SAN FRANCISCO PLANNING DEPARTMENT

MEMO

DATE: January 9, 2019

RE: Review and Comment for SFDPW Replacement and Partial Restoration of the Path of Gold Light Standards
Case No. 2018-002022COA

New Dimensions of Proposed Path of Gold Light Standards

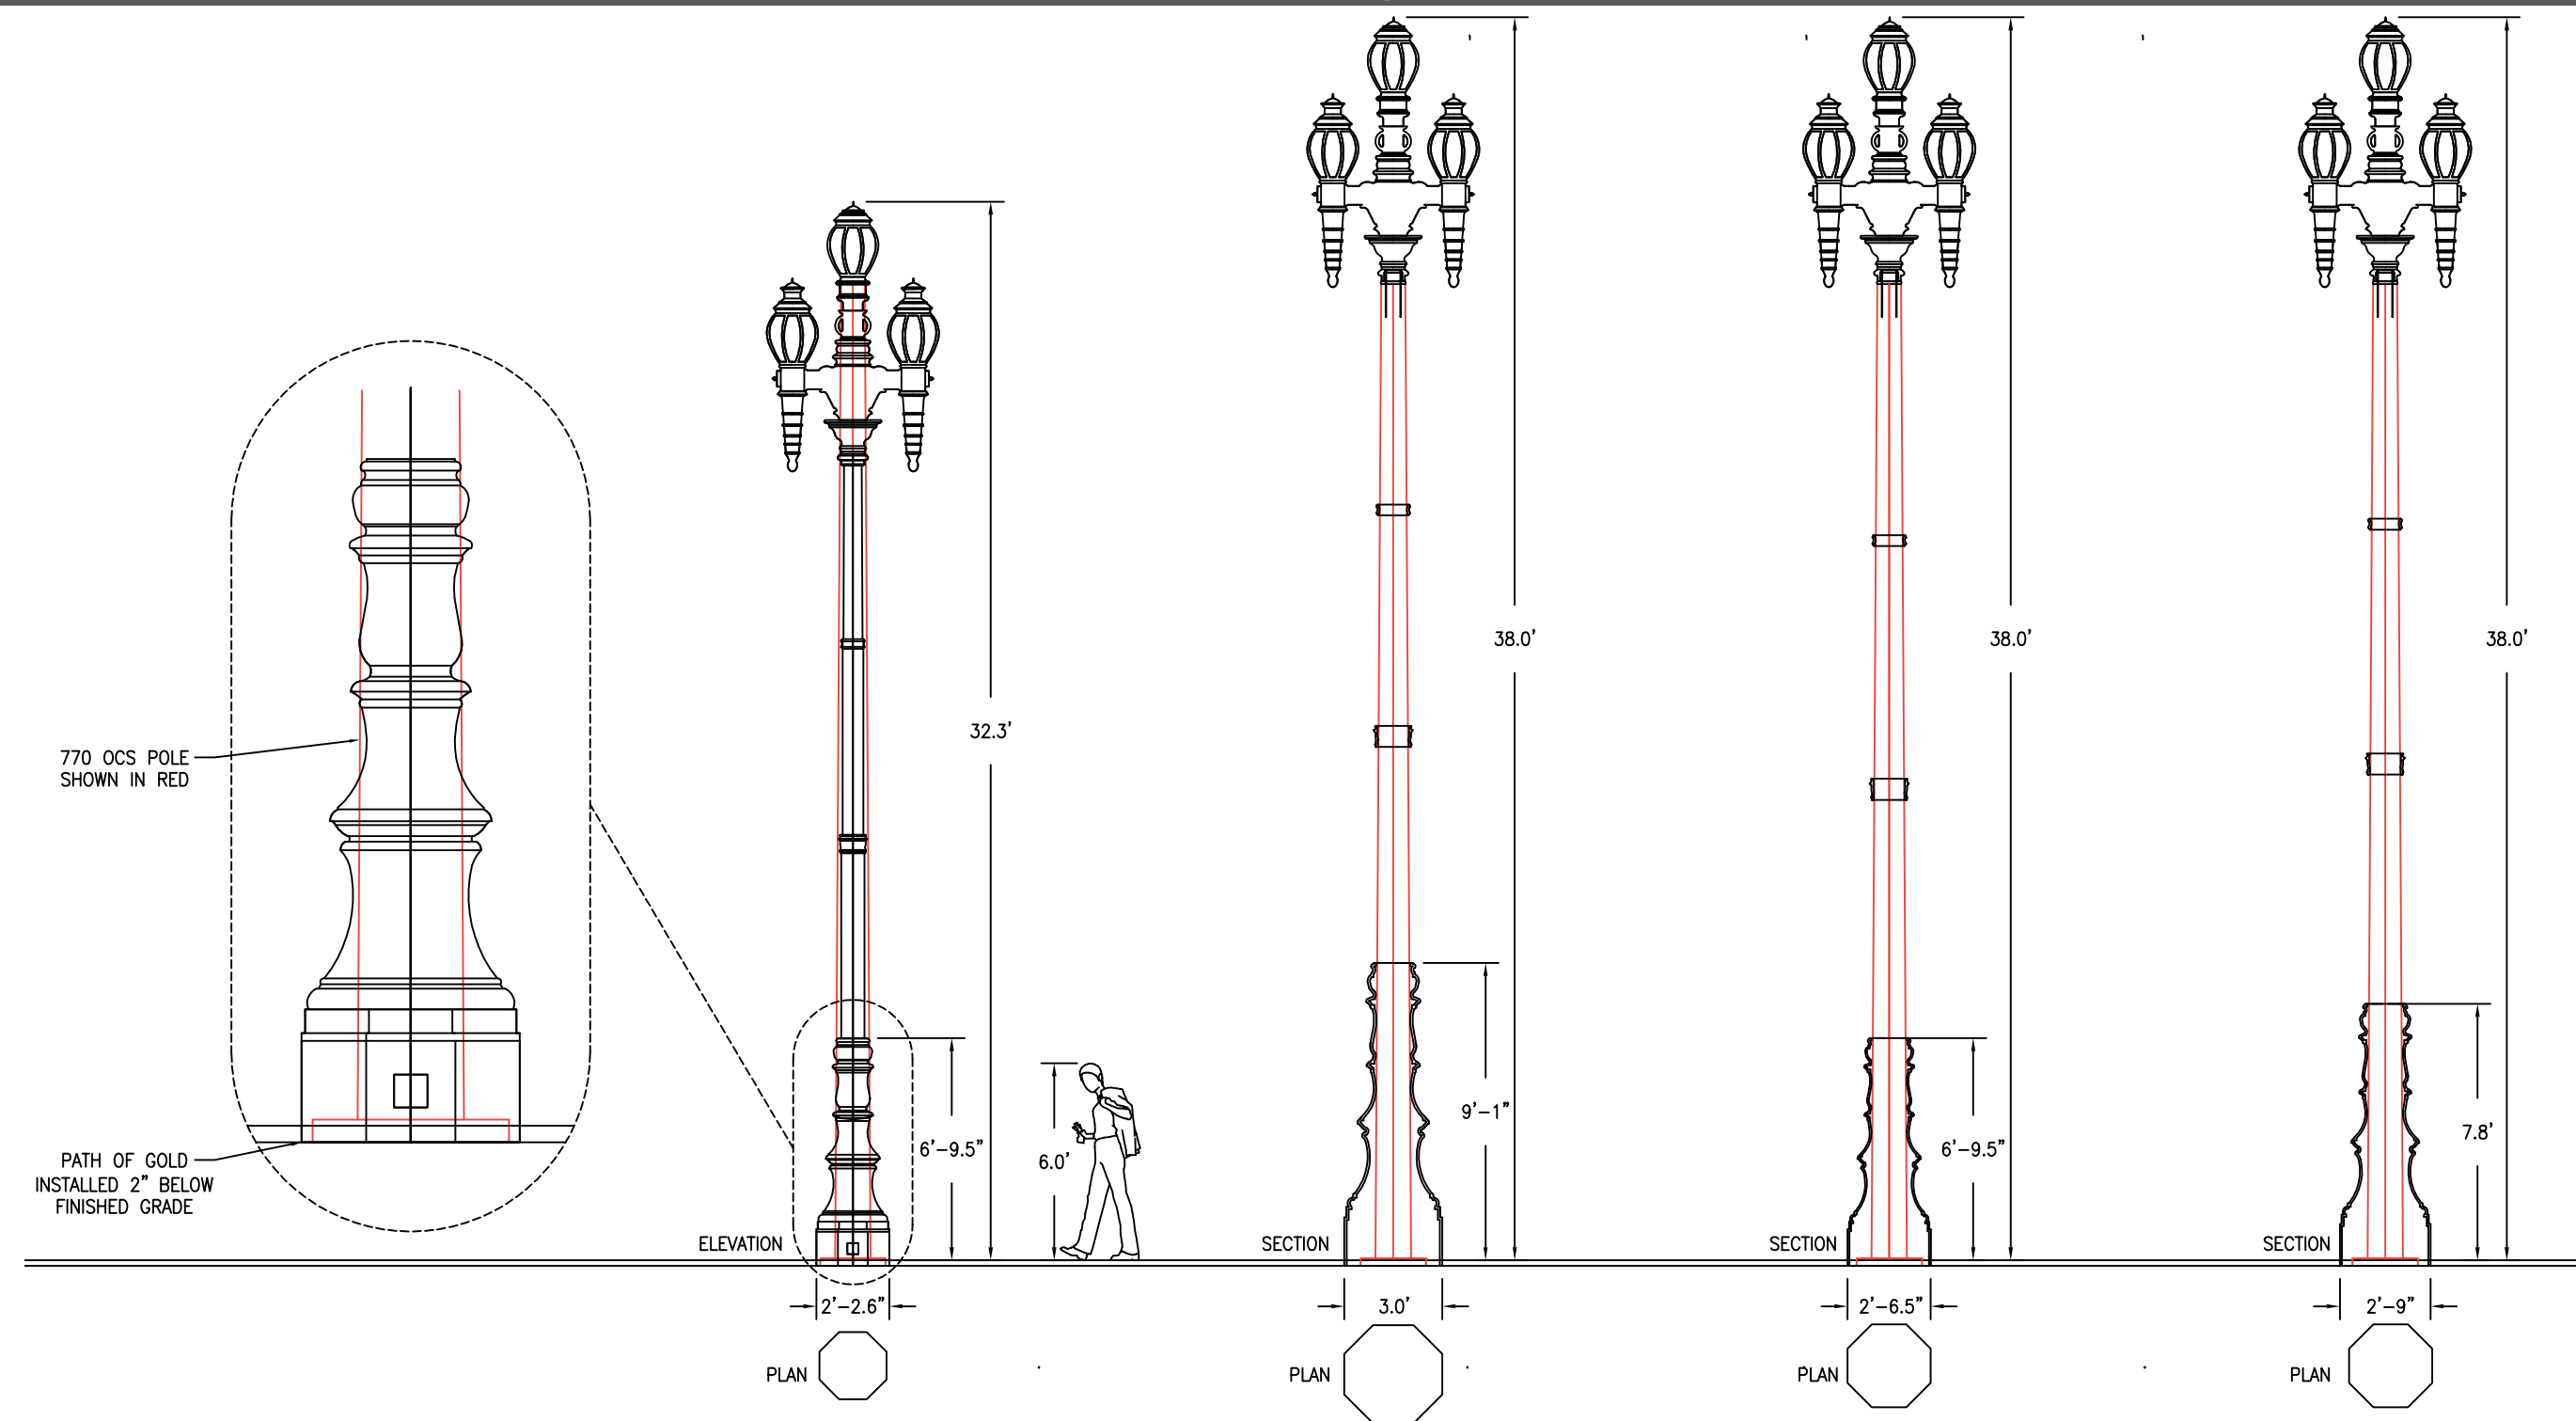
Approach: Increase size of decorative base by 15% proportionately, and increase by horizontally by 1.8" to accommodate 770 OCS. Increase size of pole rings by 15%, and space evenly between base and trident. Reuse existing trident and attach to 770 pole with custom tenon. Results: Only minor change in proportion of artwork on decorative base, and base accounts for approx. 21% of overall height (retains proportions of existing POG).

- Commissioner Pearlman asked the Project Sponsor to revise the measurements as shown in the plan(s) to be consistent with typical fractions of an inch rather than a decimal.

Alternate alignment on 1/16/19

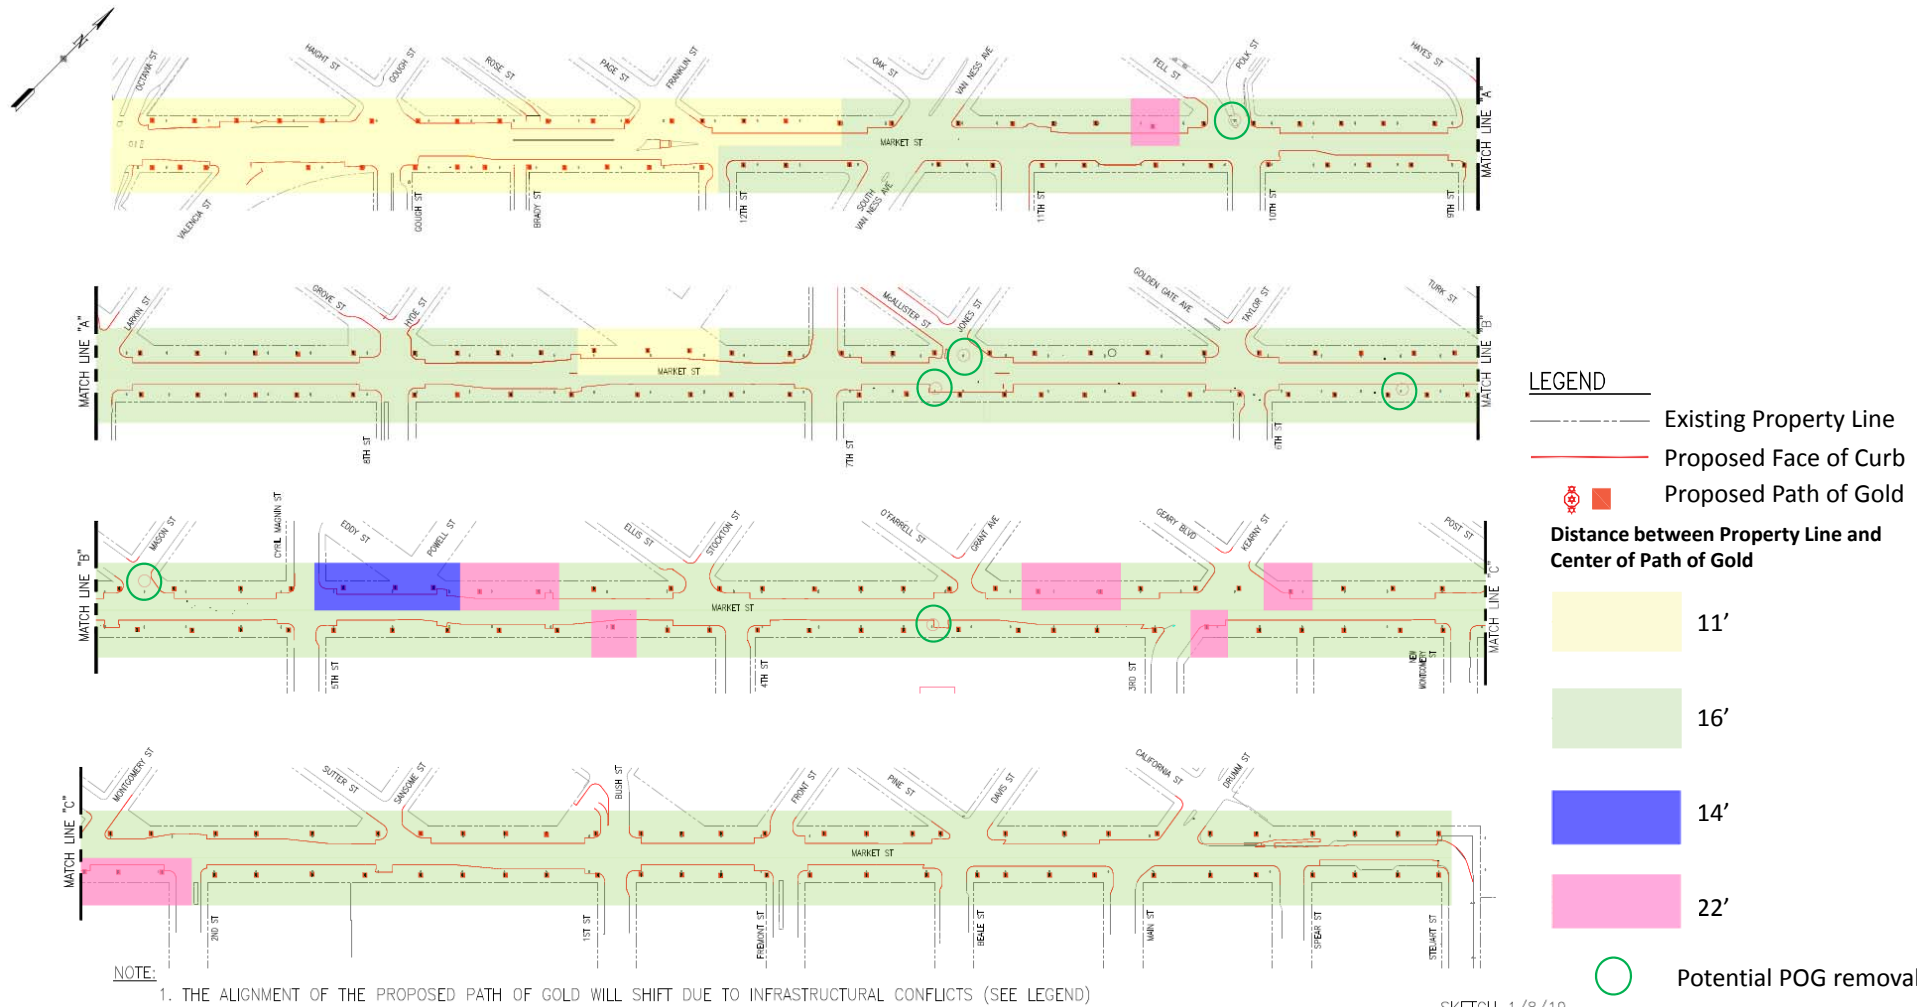
The number of standards scheduled for relocation: Approximately 14 Standards will be relocated out of alignment in areas where there are conflicts in the public-right-of-way such as furnishing zones or sub-sidewalk basement locations.

The number of standards scheduled for removal: Approximately 6 Standards will be removed completely in areas where there are conflicts in the public-right-of-way such as furnishing zones or sub-sidewalk basement locations.

The relocation and removal of Standards are illustrated in the Alternate Alignment graphic (Attachment 3). Although a total of 20 Standards have been identified to-date as needing to be relocated or removed, as the project develops further and any additional public-right-of-way conflicts are identified, there is a potential of up to – but not more than – 24.6% of the 236 overall Standards located within the project area that will need to be relocated and/or removed. The potential maximum number of Standards needing relocation or removal would be no more than 58 total Standards.

The number of Standards proposed for relocation: Staff is requesting review and comment from the ARC on the proposed relocation of approximately 14 – but potentially up to 24.6%, or 58 total Standards, –located within the project area. Staff is concerned that the Standards proposed for realignment will distort the linear character-defining nature of the landmark.

The number of Standards proposed for removal: Staff is requesting review and comment from the ARC on the proposed removal of approximately 6 – but potentially up to 24.6%, or 58 Standards.

Recommendation #1: If complete retention of the landmark in place and in its entirety cannot be achieved, then the Department recommends that a single realignment of all Standards within the project area be explored to maintain a high level of consistency and uniformity. This will maintain the character-defining nature of the landmark.

Recommendation #2: If a single realigning of all Standards within the project area cannot be achieved, then the Department recommends that realignment of Standards occur on a block-by-block basis, as current conditions exhibit, to encompass those blocks that will require a minimum of one Standard to be relocated out of alignment.

Recommendation #3: To avoid diminishing the integrity and visual character of the Landmark, the Department recommends that the Sponsor retain the Standards in their entirety, either in existing locations or through the process of relocation outlined above. The Sponsor should demonstrate where and why retention cannot occur. Complete removal of Standards should be considered only as a final option in any future application for a Certificate of Appropriateness.
